Contract Change Order # 3

Project Name: Lynn Lane WWTP Disinfection Improvements Project Number: S 1905

Lynn Lane WWTP Disinfection Improvements
CO No. 2: Emergency By-Pass System

TERTIARY
 FILTRATION P&ID

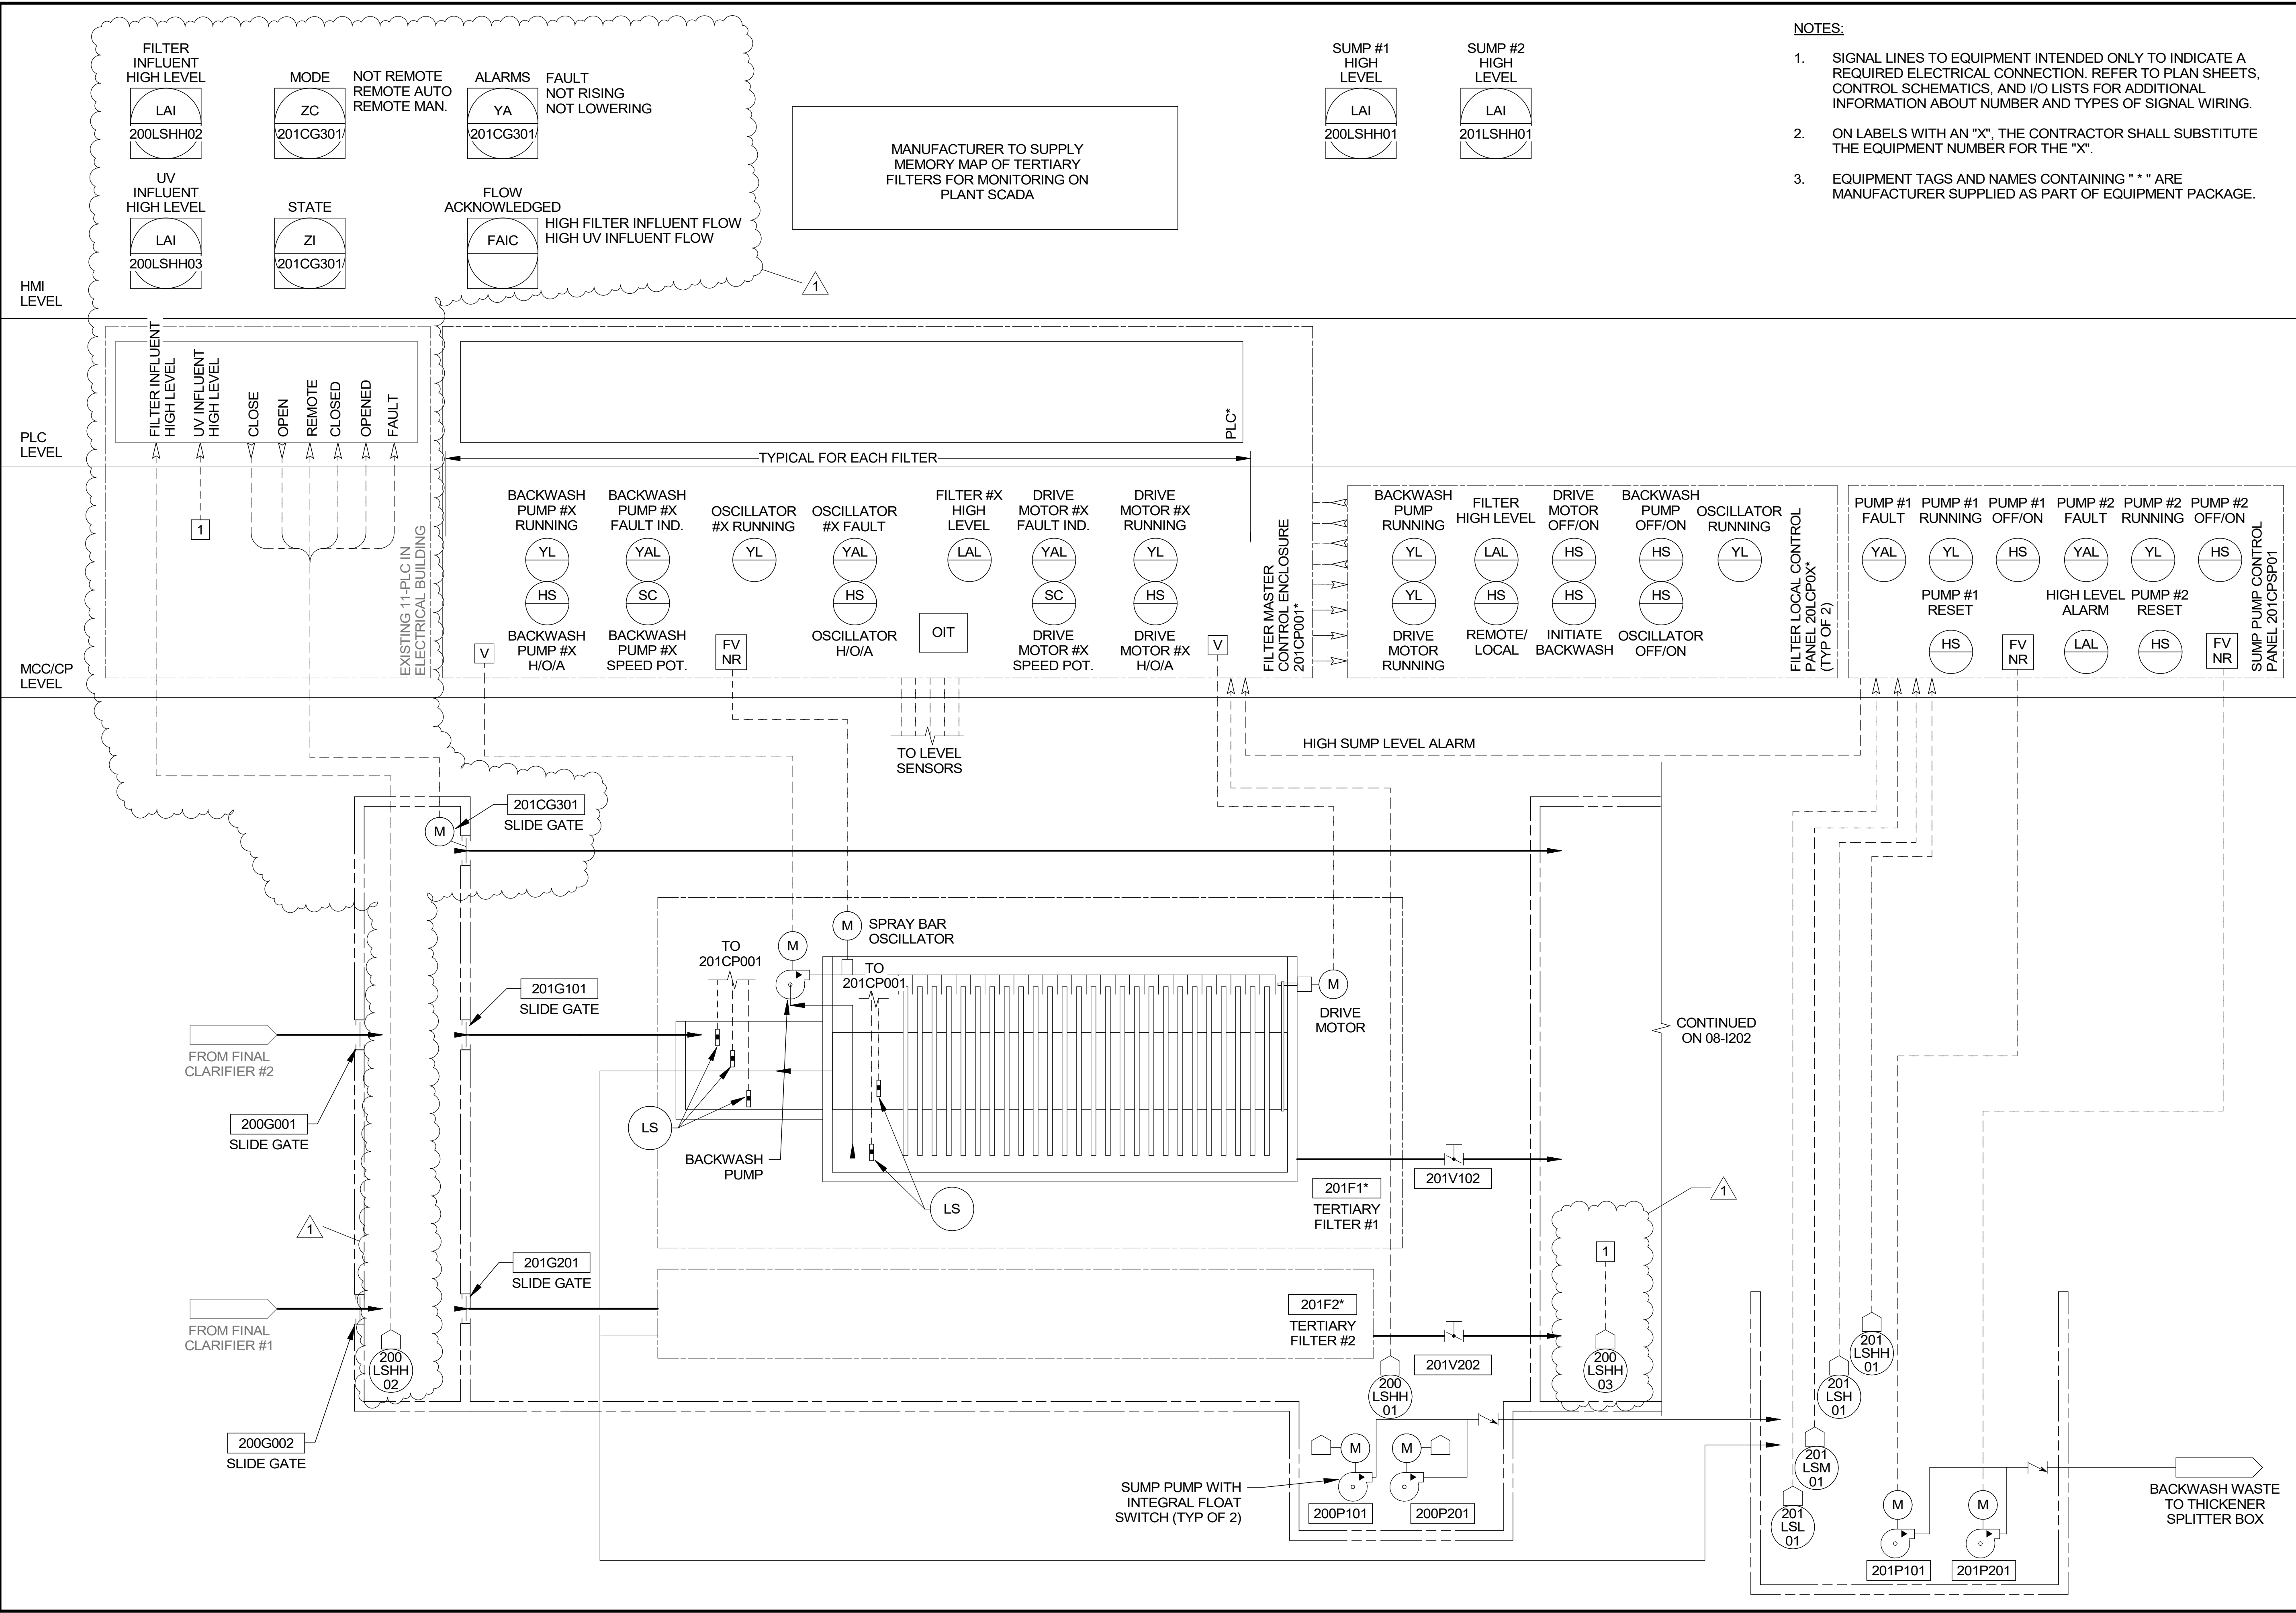
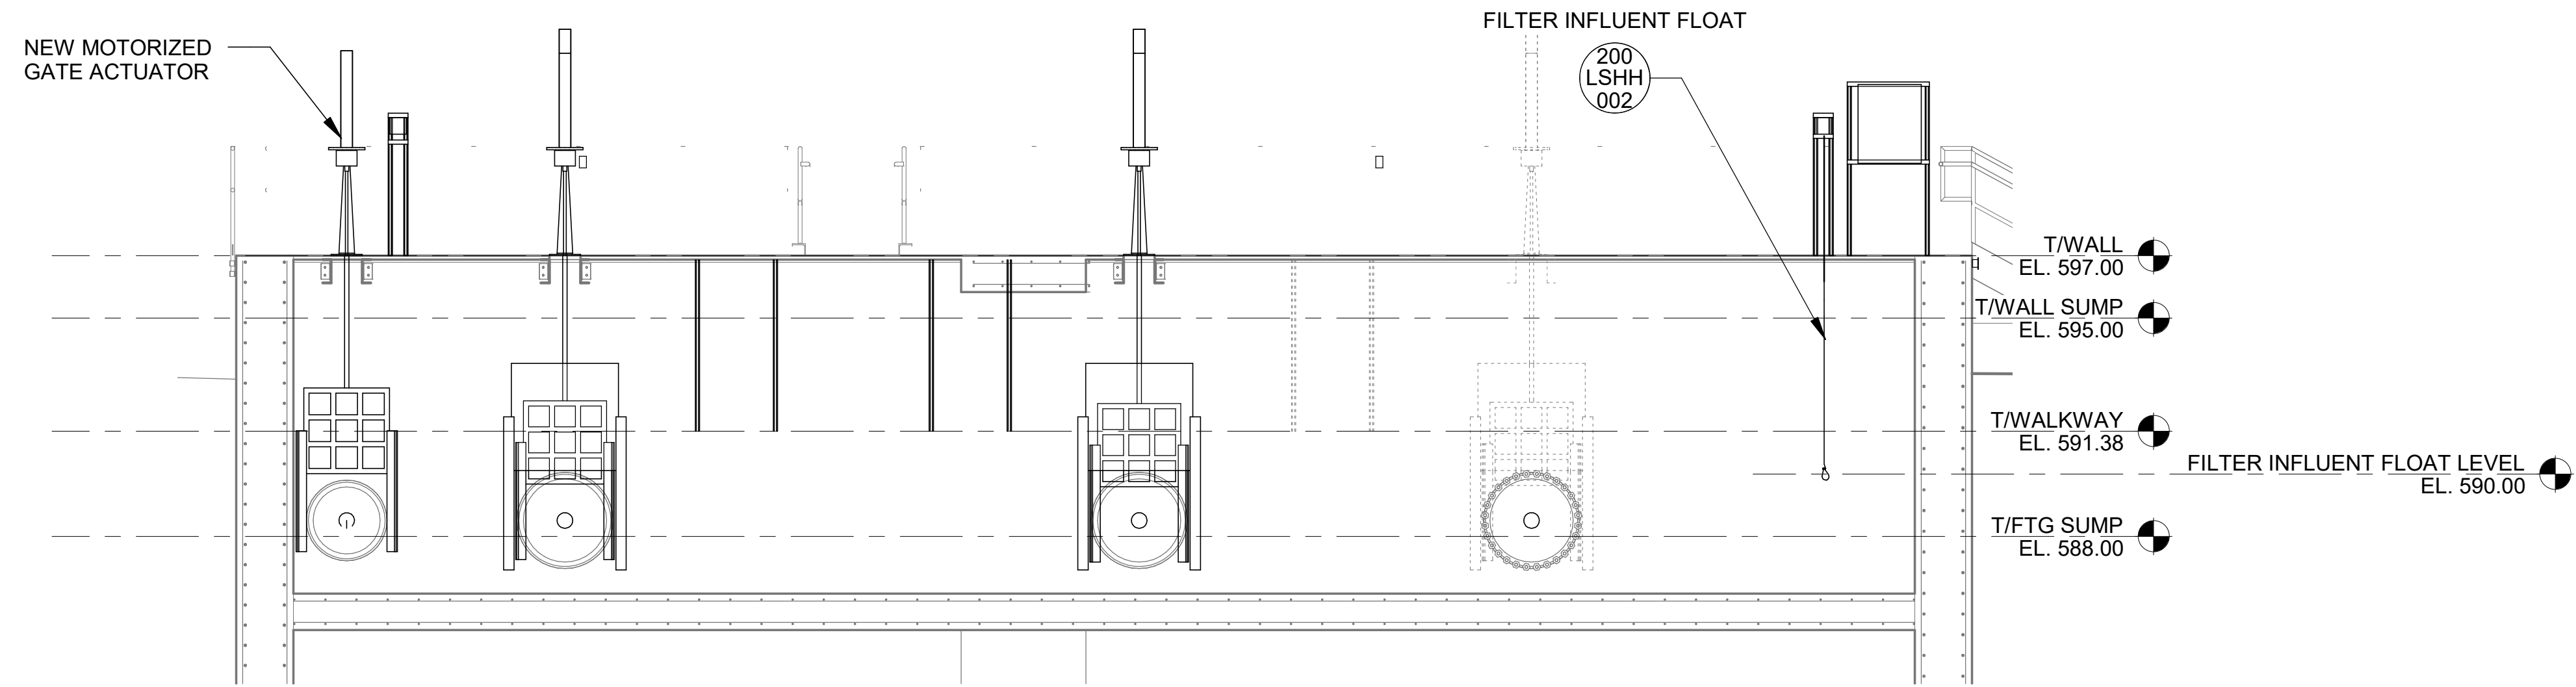
For your review. Just want to make sure yall are good with this, and our assumptions are valid. Below is control methodology attached is our updated drawing and schematics. Hopefully this is enough upon approval to get a quote from crossland

Our proposed control would be:

When the FILTER INFLUENT HIGH LEVEL is detected from float switch 200LSHH02, 11-PLC opens the filter bypass gate.

The gate would remain open until someone acknowledges a return to normal flow.

When normal flow is acknowledged 11-PLC will then close the bypass gate, or the gate actuator may be operated by hand (open/close) locally.

If the UV INFLUENT HIGH LEVEL is detected from float switch 200LSHH03 a “NO FLOW” indication is communicated to the UV control panel via Ethernet from the SCADA system.

The UV control panel will then open the gates to all the UV vessels for unrestricted flow in this condition.

The system would remain in this high flow state until someone acknowledges a return to normal flow (same acknowledgment as above).

When normal flow is acknowledged the “NO FLOW” indication to the UV CP will cease, and the UV system will return to normal operation.

FLOAT LEVELS

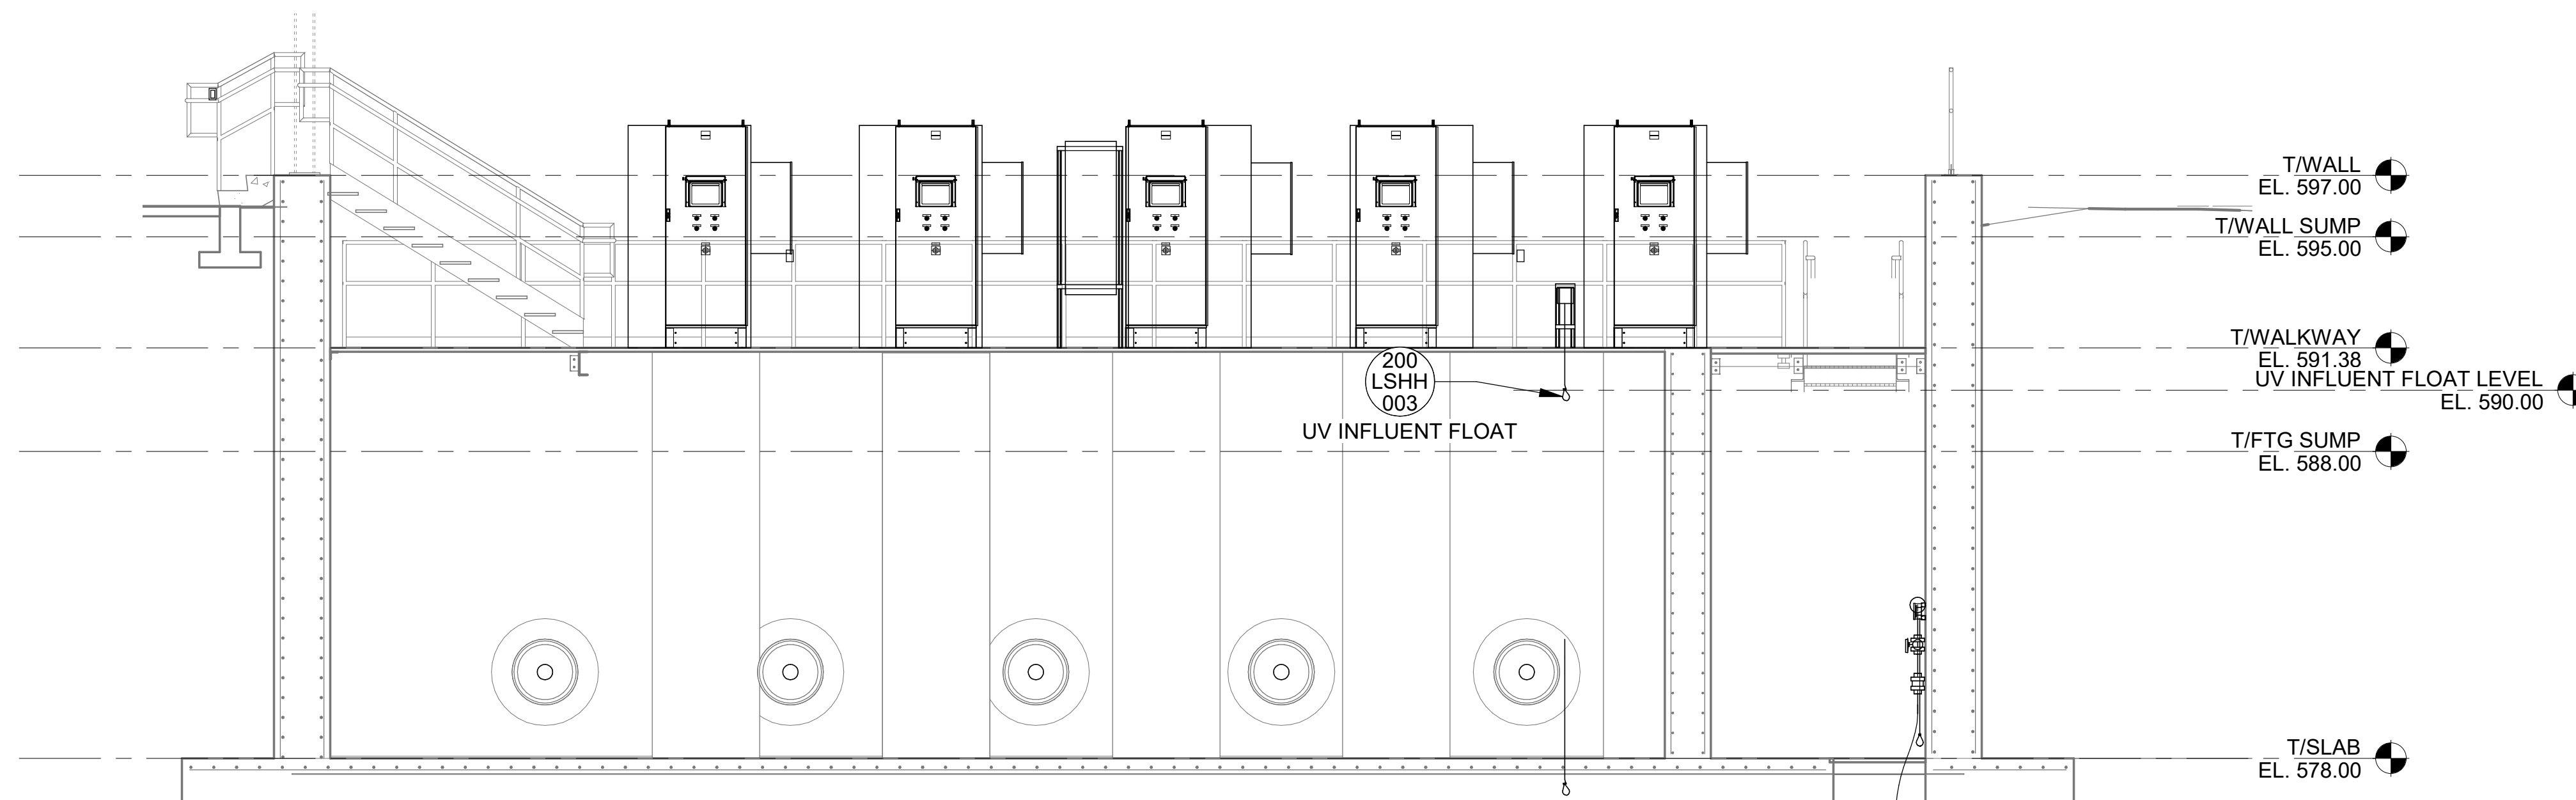
Gate actuator and (2) float switch installations.

Junction boxes and I/O terminals for gate actuator and float switches.

Conduit and conductors from (a single 14GA 15-conductor cable or equal would work) the UV/Filter area to the existing 11-PLC control panel. (We need confirmation of an existing spare conduit in the duct bank that was just installed between the new disinfection facility and existing electrical building where 11-PLC is located.)

Power conduit and conductors from 480V panel 20DP2 to gate actuator.

PLC/SCADA programming and I/O termination at existing 11-PLC will also be required.
